Technical Note

Project:	Finchwood Park Parcels 11 & 12	SMA Ref:	7292.TN08
Subject:	Response to WBC Highways Comments	Revised:	B – 16.10.2025
Prepared by:	Tyler Andrews	Date:	06.08.2025
Checked by:	Kate Marshall	Date:	07.08.2025

This Technical Note (TN) has been prepared by Stuart Michael Associates Limited (SMA) on behalf of Vistry Homes to address the comments received and information requested from the Local Highway Authority - Wokingham Borough Council (WBC) dated the 26th June 2025 on Application No: **250931**.

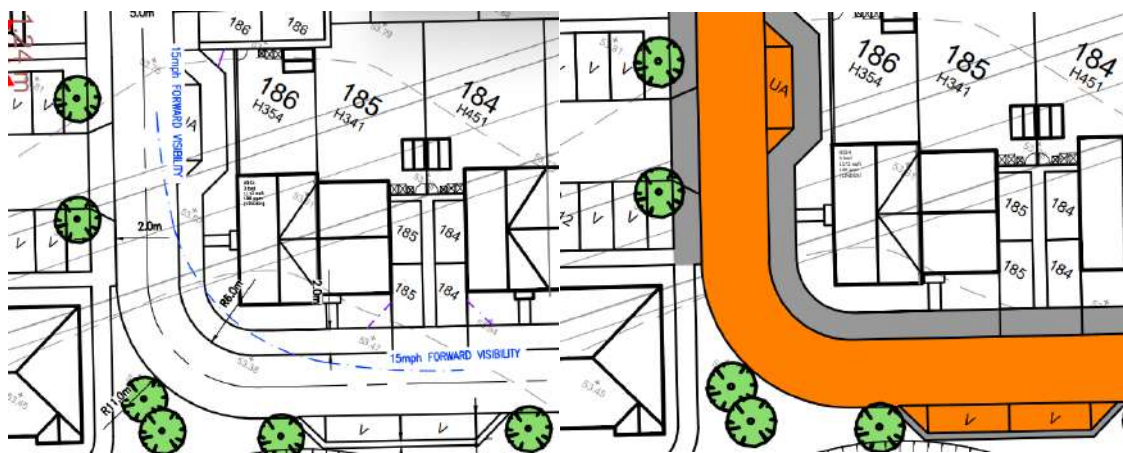
Forward visibility of 25 metres should also be demonstrated around the bend for the 20mph speed limit, as only a 15mph visibility has been shown. The LHA are concerned that without suitable passing space and without suitable forward visibility there could be conflicts between refuse vehicles and cars travelling around the bend. Screenshots of the refuse vehicle overrun and measurements of carriageway width are provided below.

The refuse vehicle tracking has now been amended to remove these areas of overhang. A refuse vehicle can pass a car for the majority of the access roads across the site, aside from in a few pinchpoints around the bends in the alignment. However, in the areas where these vehicles cannot pass each other, it has been ensured that there is sufficient visibility for a car to recognise the refuse vehicle and stop or pull to one side to allow it to pass. It should be noted that the frequency of this is likely to be once a week or less. This bend is designed at 90 degrees to act as a speed control feature and therefore vehicle speeds will naturally be lower and the 15mph forward visibility splay currently shown will be sufficient.

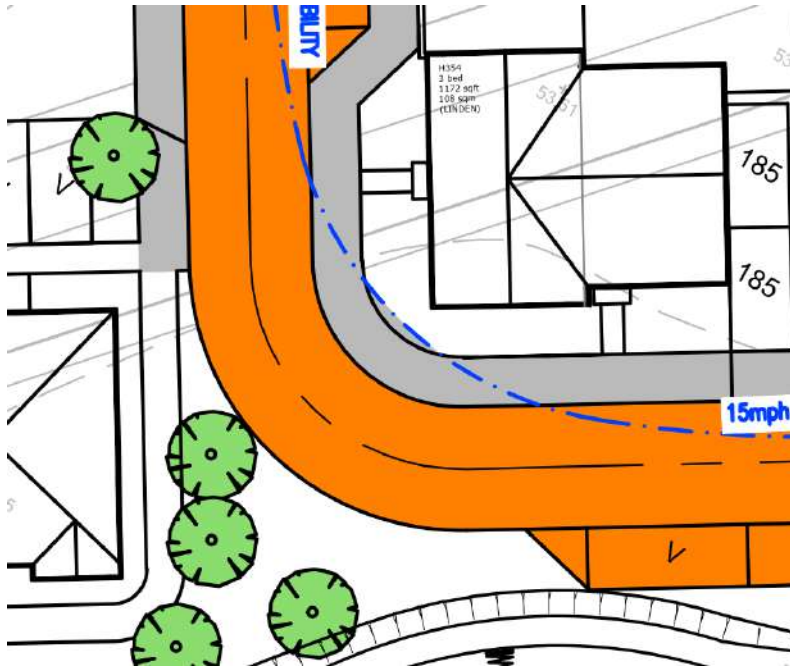
Furthermore, the 15mph visibility splay shown passes through land which is not offered for adoption as public verge/highway. Therefore, the 15mph visibility is not only substandard; but cannot be guaranteed given a fence could be erected within the splay. Screenshots highlighting the problem are provided below:

The proposed adoption plan has now been updated to ensure that any land within visibility splays is offered as part of the adoption process to the local authority. See extract below:

DRAWING TITLE
**PARCEL 11 AND 12
GENERAL ARRANGEMENT
SHEET 1 OF 2**

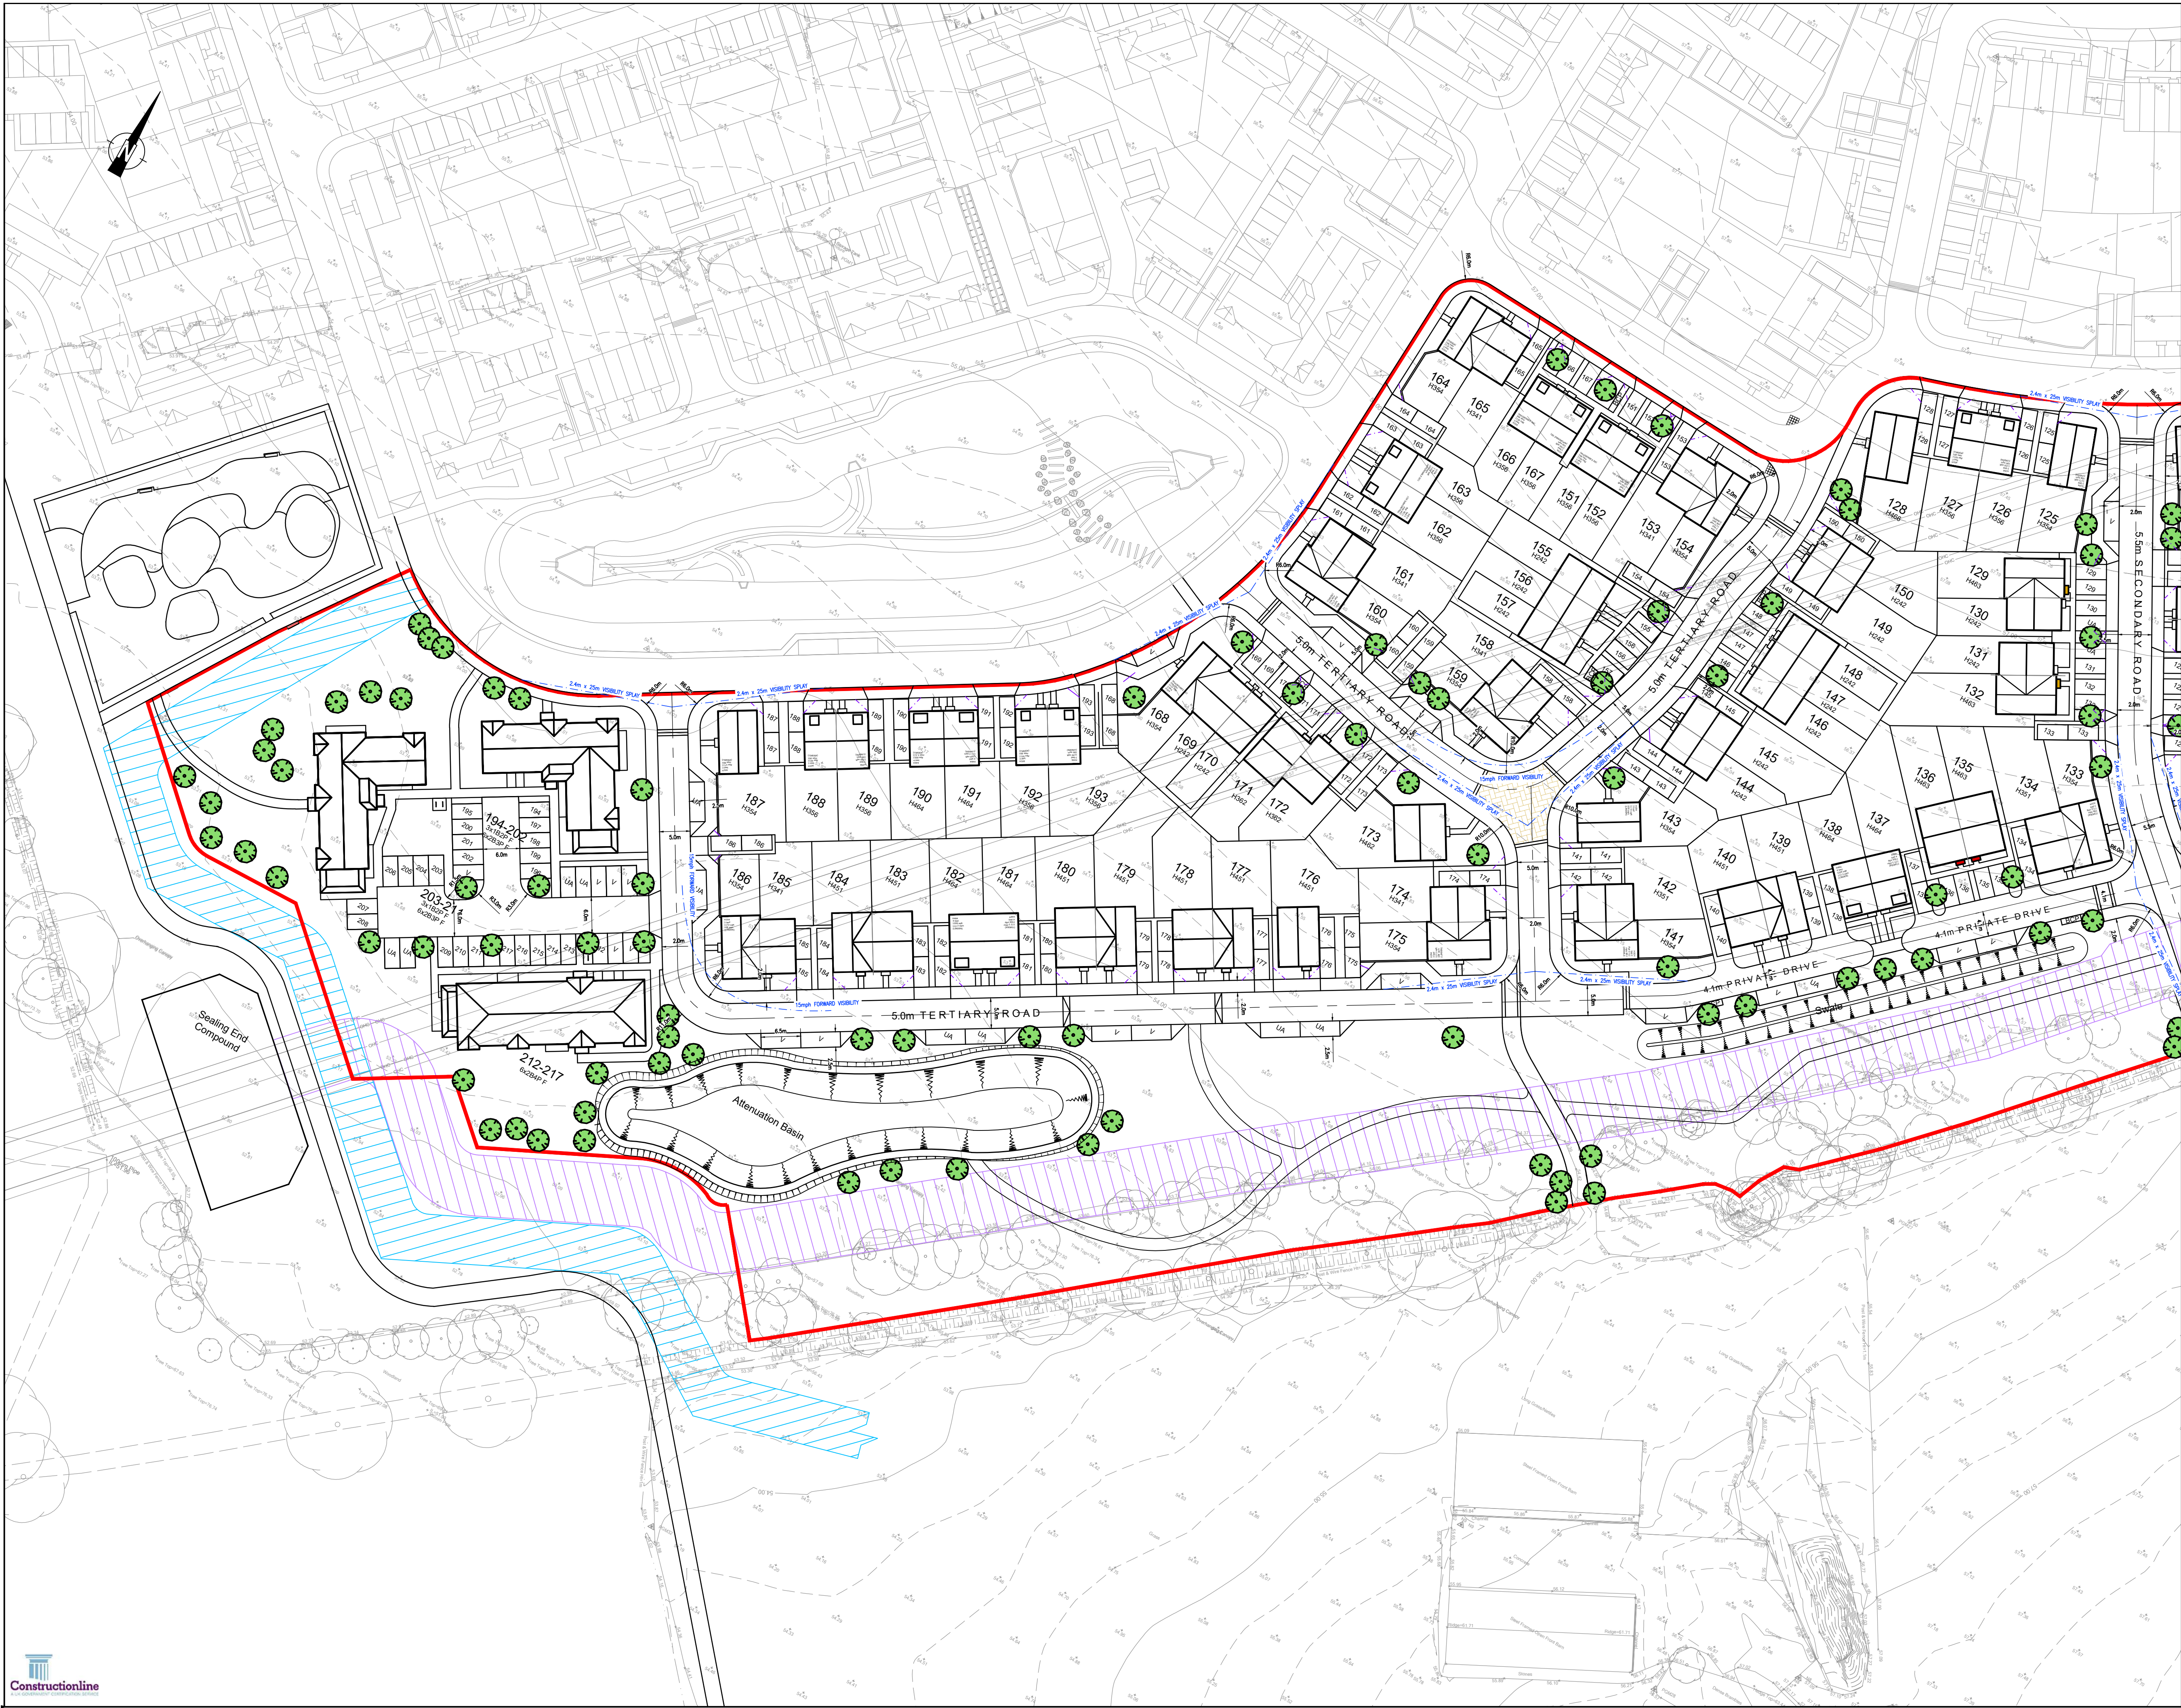
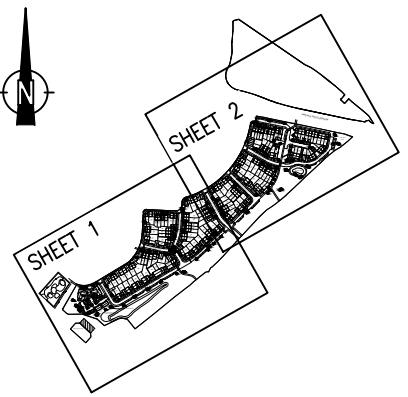
The LHA require the provision of physical speed reduction features between Plots 175 – Plot 186. This section of straight road is c.127m long and would result in vehicles exceeding the target speed of 20mph.

- *Features reducing vehicle speeds should be provided at 50-80m centres. Whilst this could take the form of traffic calming, good design should avoid the need for engineering features.*

The road alignment in this area has been reviewed, and a raised table is now proposed to the front of plots 178-180 to act as a traffic calming feature. Refer to the general arrangement drawings included under Appendix A on this note.

JOB TITLE
FINCHWOOD PARCELS 11, 12 & 13
DRAWING TITLE
**PARCEL 11 AND 12
REFUSE VEHICLE TRACKING
SHEET 1 OF 2**

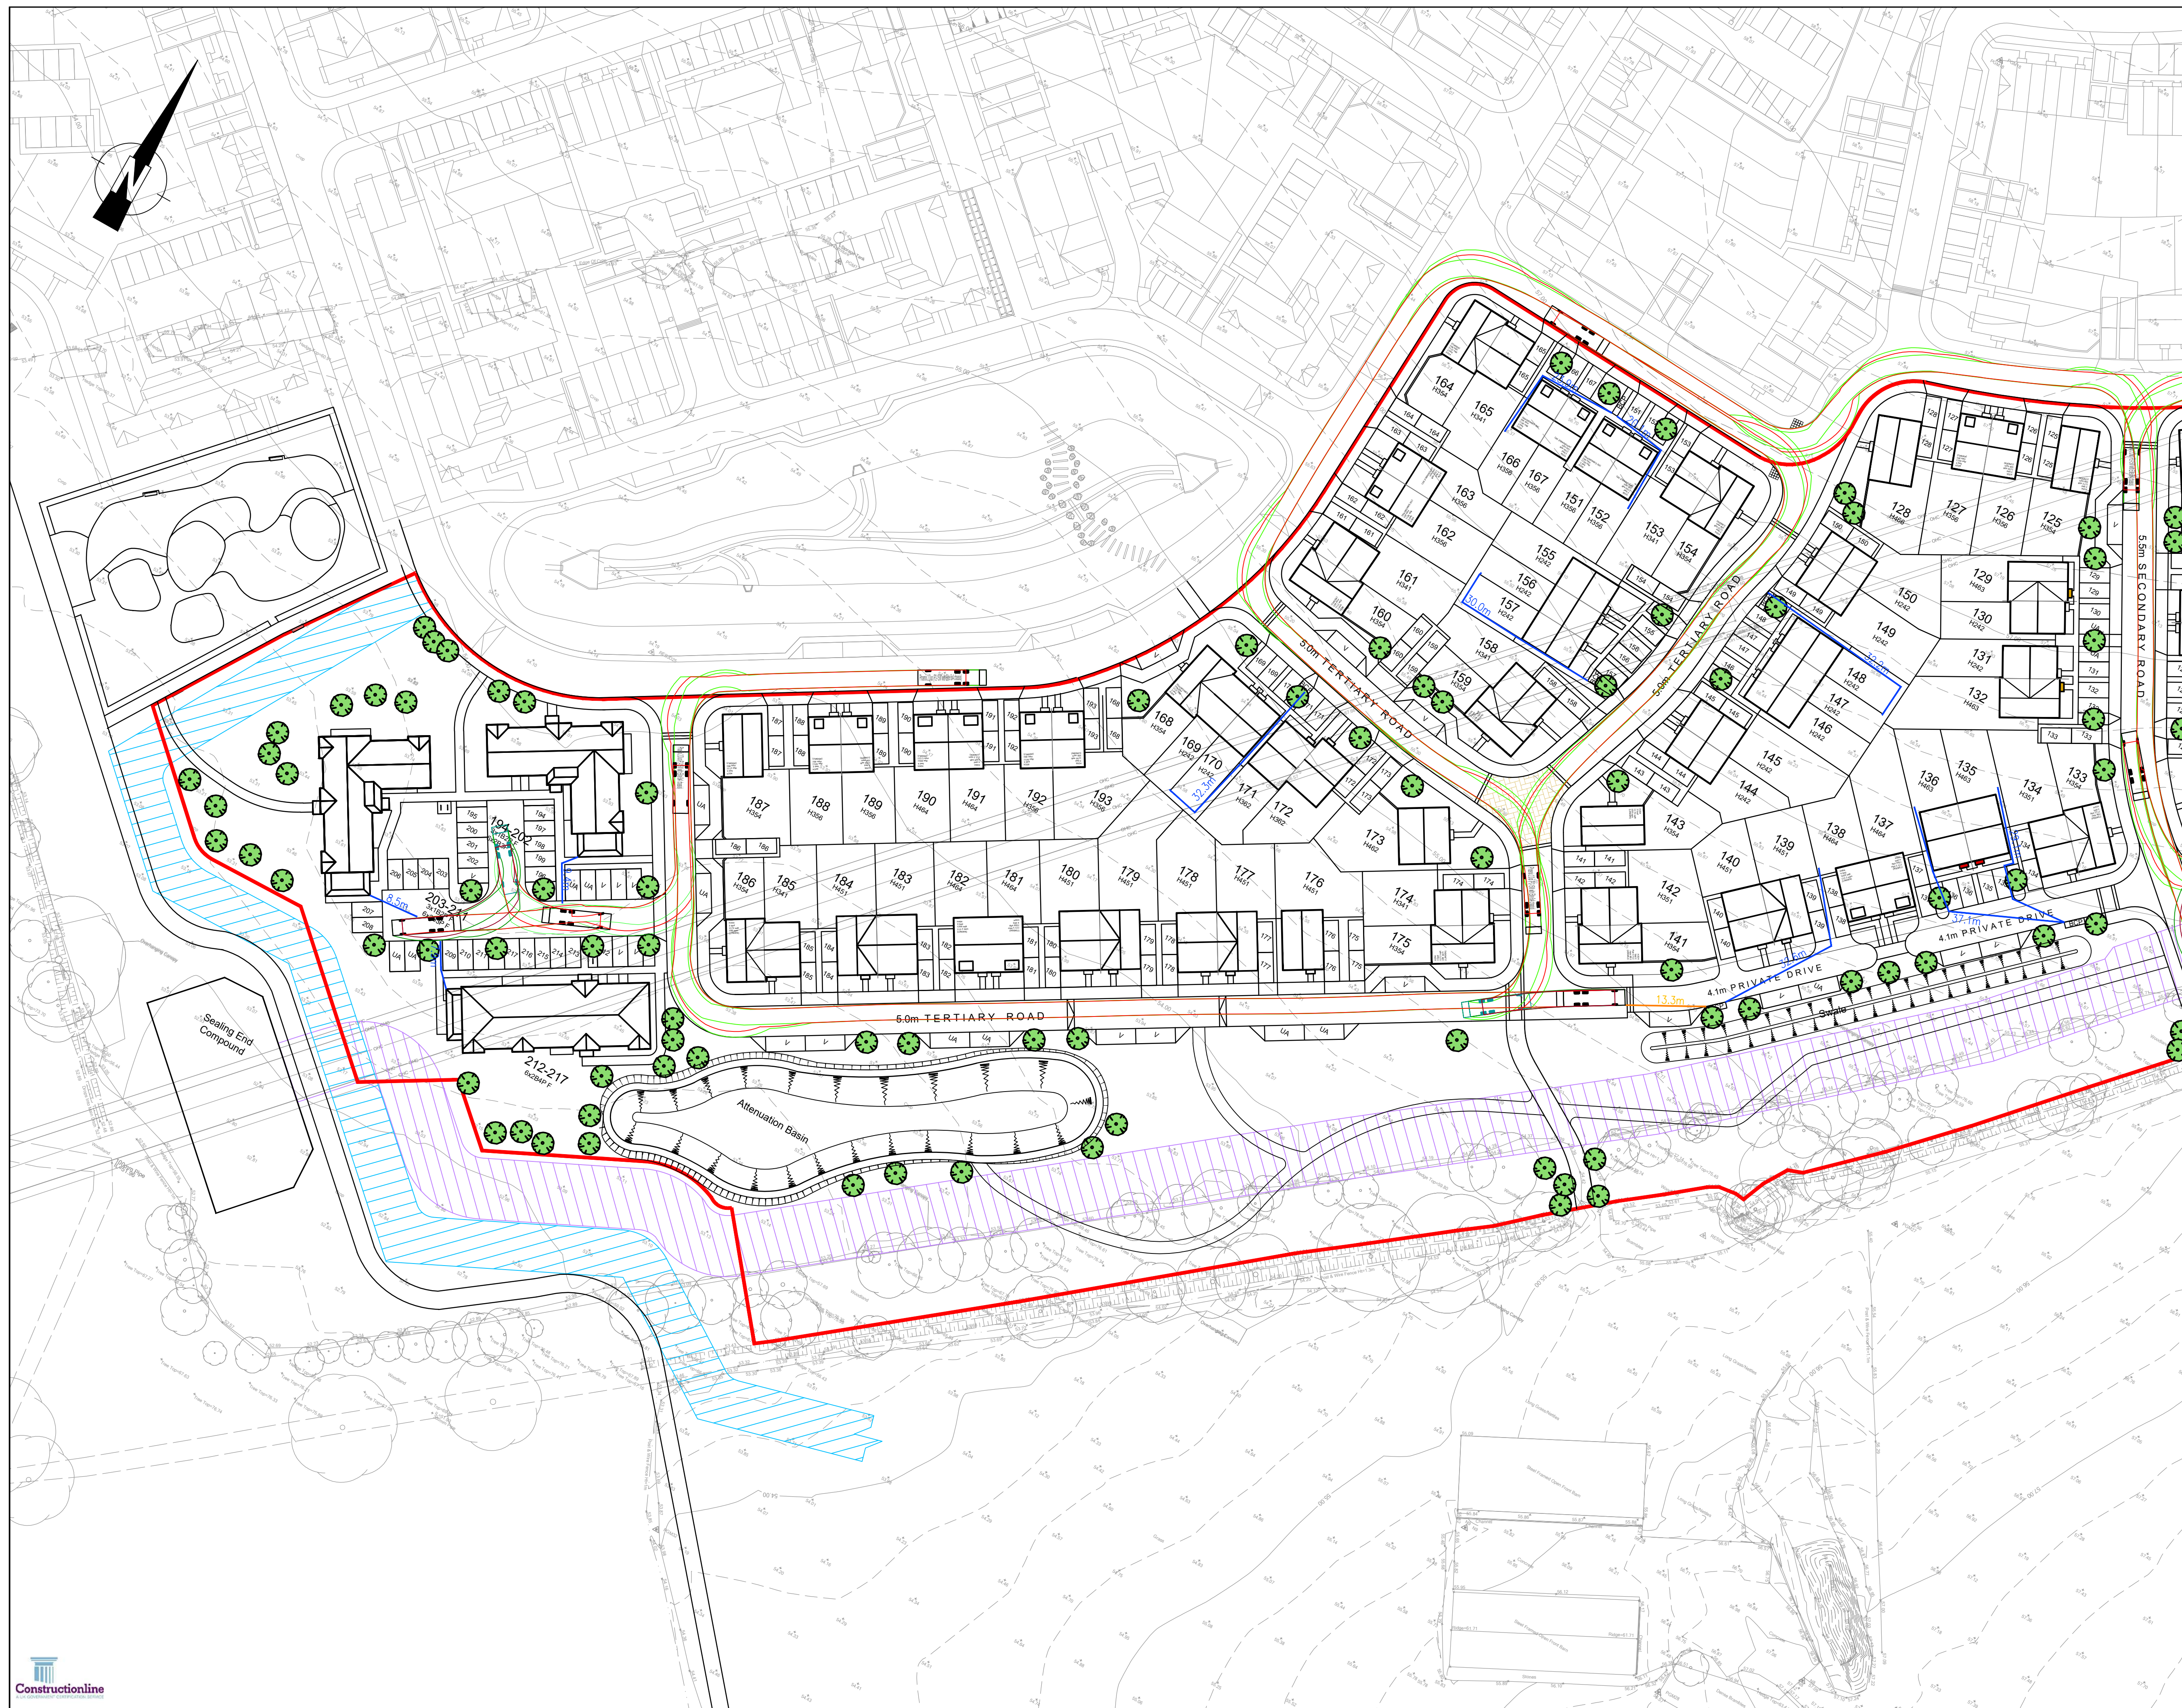
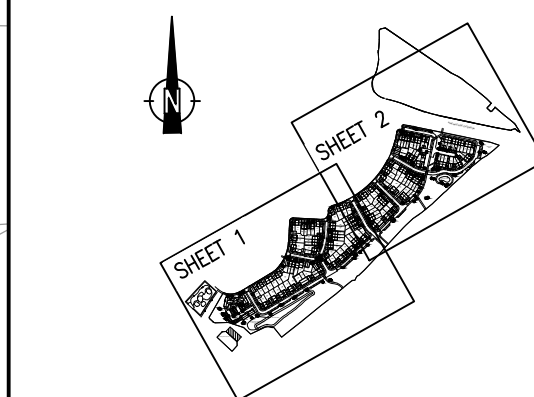
The swept paths for a refuse vehicle show that there are 3 areas where a refuse vehicle body and chassis would overrun the footway to the south-west of Plot 186.

The swept paths should show that a refuse vehicle and a large can pass each other (as per the preapplication advice provided by the LHA).

The LHA require the applicant to adjust the carriageway width, corner radii and provide amended swept paths which demonstrate a refuse vehicle will not overrun the footway and risk pedestrian safety.
